UNITED STATES PATENT AND TRADEMARK OFFICE

APPLICATION NO.	FILING DATE	FIRST NAMED INVENTOR	ATTORNEY DOCKET NO.	CONFIRMATION NO.
10/646,655	08/21/2003	Jee-Hoon Kim	404302001300	9940

Office Action Summary	Application No. 10/646,655	Applicant(s) KIM ET AL.	
	Examiner Mohammed Hasan	Art Unit 2873

DETAILED ACTION

Figure 5

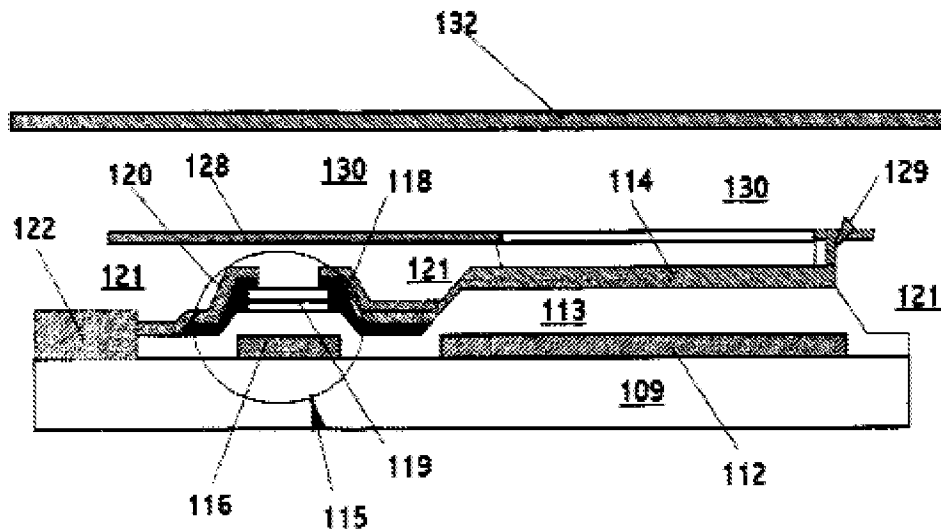
Regarding claim 7, Lee discloses including a backlight positioned such that the light sensitive transistor and switch are positioned between the glass substrate and the backlight (as shown in figure 5).

Regarding claim 10, Lee discloses (refer to figures 4-5) an image capture sensor including: a light detection transistor (TFT transistor) including a light sensitive layer which conducts electricity in response to detection of a predetermined amount of light; a switch (115) interconnected to the light detection transistor and responsive to detection of light by the light detection transistor; a glass substrate (109) layered over the light detection transistor and switch and upon which a patterned object to be imaged is placed (column 3, lines 60-67, column 4, lines 1-25).

Figure 5

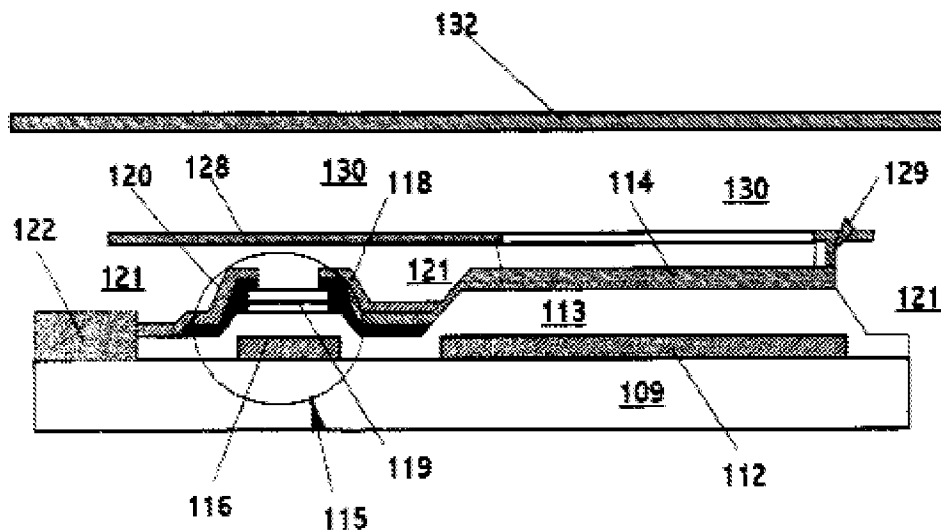
Regarding claim 14, Lee discloses (refer to figures 4-5) an image capture sensor including: a light detection transistor (TFT transistor) including a light sensitive layer which conducts electricity in response to detection of a predetermined amount of light; a switch (115) interconnected to the light detection transistor and responsive to detection of light by the light detection transistor; a glass substrate (109) layered over the light detection transistor and switch and upon which a patterned object to be imaged

in placed , the substrate including fiber-optic strands (column 3, lines 60-67, column 4, lines 1-25).

Regarding claim 15, Lee discloses further including a capacitor that interconnects the light detection transistor and the switch (as shown in figure 5).

Regarding claim 16, Lee discloses wherein the switch is a transistor switch (as shown in figure 5).

Regarding claim 17, Lee discloses including a first light shielding layer that reduces the amount of light to which a first surface of the light sensitive layer is exposed (as shown in figure 5).

Regarding claim 18, Lee discloses wherein the fiber-optic strands are formed perpendicularly to a surface of the substrate (as shown in figure 5).

Regarding claim 19, Lee discloses wherein the object to be imaged is a fingerprint (as shown in figure 5).
